SUBJECT: Entergy Nuclear Operations Inc.
Indian Point Nuclear Generating Unit Nos. 2 & 3
Docket Nos. 50-247 and 50-286
Amendment 3 to License Renewal Application (LRA)

This letter contains Amendment 3 of the License Renewal Application (LRA), which consists of five attachments. Attachment 1 consists of an amendment to the LRA to address Regional Inspection items. Attachment 2 consists of an amendment to address Audit Time Limited Aging

**NRC Regional Inspection
License Renewal Application
Amendment**

Figure 2.5-2
IP2 Offsite Power Scoping Diagram

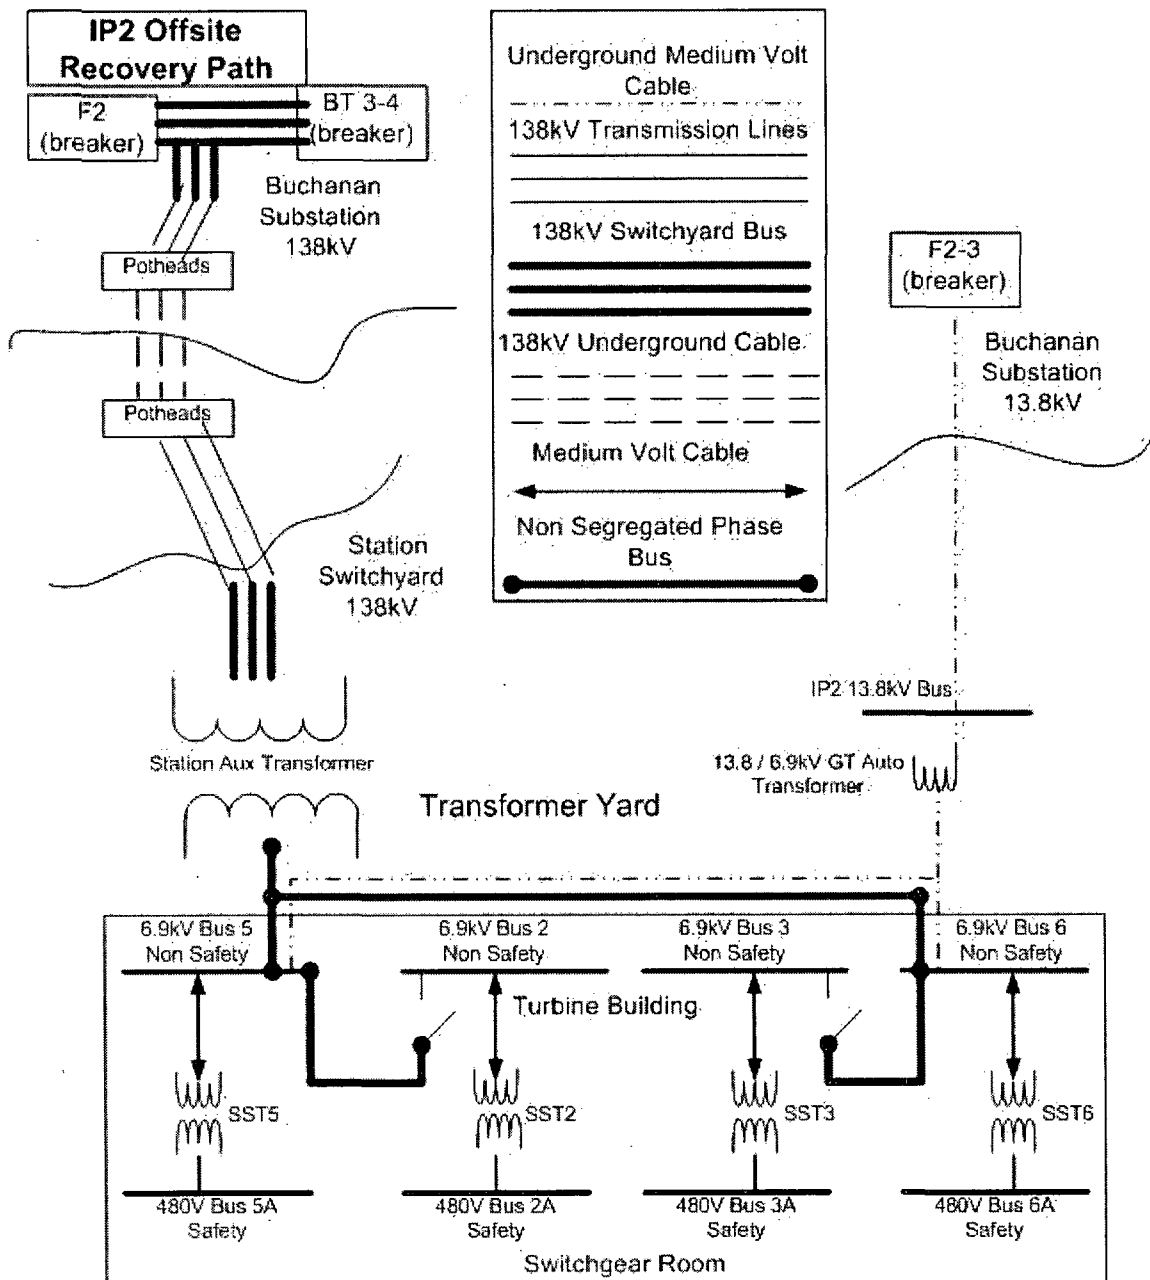
Based on discussion with the NRC Staff on 12/4/07 and industry discussion with the NRC Staff on 12/12/2007 and 1/30/2008, the response to this RAI provided in Entergy Letter NL-07-138, Dated 11/16/2007 is being revised. The only section that requires revision is LRA Figure 2.5-2 and associated discussion.

As shown in the revised LRA Figure 2.5-2, the 6.9 kV buses receive offsite power from either the 138 kV / 6.9 kV station auxiliary transformer or the 13.8 kV / 6.9 kV GT autotransformer. The station auxiliary transformer is connected to the 138 kV Buchanan substation, the primary offsite power source, via switchyard bus, overhead transmission conductors, and underground transmission conductors through ~~motor-operated disconnect F3A~~ switchyard breakers F2 and BT 3-4, which ~~is~~ are located at the Buchanan substation. The GT autotransformer is connected to the 13.8 kV Buchanan substation, the secondary offsite power source, via underground medium voltage cable through breaker F2-3, which is located at the Buchanan substation.
